### Response to Anonymous Referee #3

*RC: This study proposes a new classification of streamflow drought hazard indicators (SDHI) to guide researchers or practitioners in selecting an appropriate indicator(s) for their objective(s). In order to demonstrate the importance of the proper selection of SDHIs in a drought assessment, the authors compared eleven SDHIs, including three new indicators, and quantified their similarities and discrepancies. Because human society and ecosystems adapt to a local streamflow regime, this study underscores their habituation implicitly assumed in each SDHI. This includes how one can define a normal condition and a condition under a lack of water. In this context, the results show that drought severity, i.e., accumulated drought magnitude, rather than mere magnitude at a time step, may need to be evaluated to investigate prolonged drought events. The dry season in the arid region, which is not suitable for a conventional threshold method, and the water deficit in comparison to water demand are also paid particular attention in this study. Classifying SDHIs and organizing their features, as a result, the authors stress that one needs to select an app

**Figure 3:** Percent deviations of simulated Q80 per calendar month from Q80 based on GRDC observations using the reference period 1986-2015.

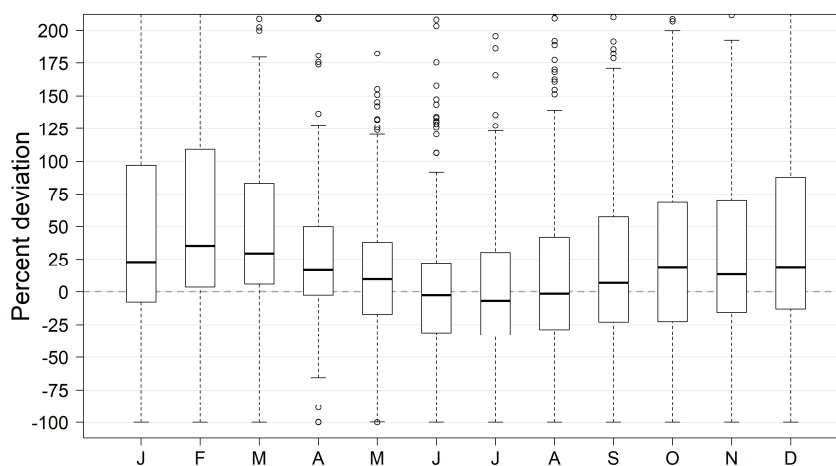
*RC: I require the authors to present a more description on the model validation concerning stream drought reproducibility. Currently, no figure has been presented for section 3.4. Also, I expect an additional analysis to evaluate how well the simulated stream flow data reproduce hydrological drought events detected by the observation data. I would say that, at least, the comparison of observation- and simulation-based drought detections at the selected two gauge stations should be presented similarly to Figure 2.*

**AC:** In the model validation (new Sect. 4.1), we added the new Fig. 3 below for a more detailed analysis of Q80. Furthermore, we added the paragraph below Fig. 3 describing the results of another recent WaterGAP 2.2d model validation performed by us comprising 183 gauging stations. Hence, the model validation is now focused on Q80 and a SDHI (SSI3), which are both relevant for the subsequent global-scale analysis of SDHIs.

In a recent study, WaterGAP 2.2d model output was validated against GRDC data by comparing SSI3 based on simulated and observed monthly streamflow (SSI3(sim) and SSI3(obs)) during 1971-2000 at 183 globally distributed GRDC stations (Wan et al. 2021). Applying drought hazard classes for SSI according to Agnew (2000), the agreement between simulated and observed hazard classes in each month was analyzed. Among all stations, the agreement ranged between 29 to 88% of all 360 months (their Fig. S4 and Table S3). At 68% of all stations (covering 83% of the assessed basin area), SSI3(sim) and SSI3(obs) resulted in the same drought hazard class in 70 to 88% of the time. Moreover, the goodness-of-fit was evaluated based on the Nash-Sutcliffe efficiency (NSE) for monthly streamflow and SSI3 (their Fig. S3). With a median NSE of 0.5 and an interquartile range of 0.2-0.7 for SSI3 and 0.14-0.7 for streamflow, WaterGAP 2.2d model output showed a moderate agreement with the observations. Both NSEs exceeded 0.7 at 25 out of the 183 stations, which are located in Central and Eastern Europe (twelve stations), the United States (ten stations), and South Africa (one station).
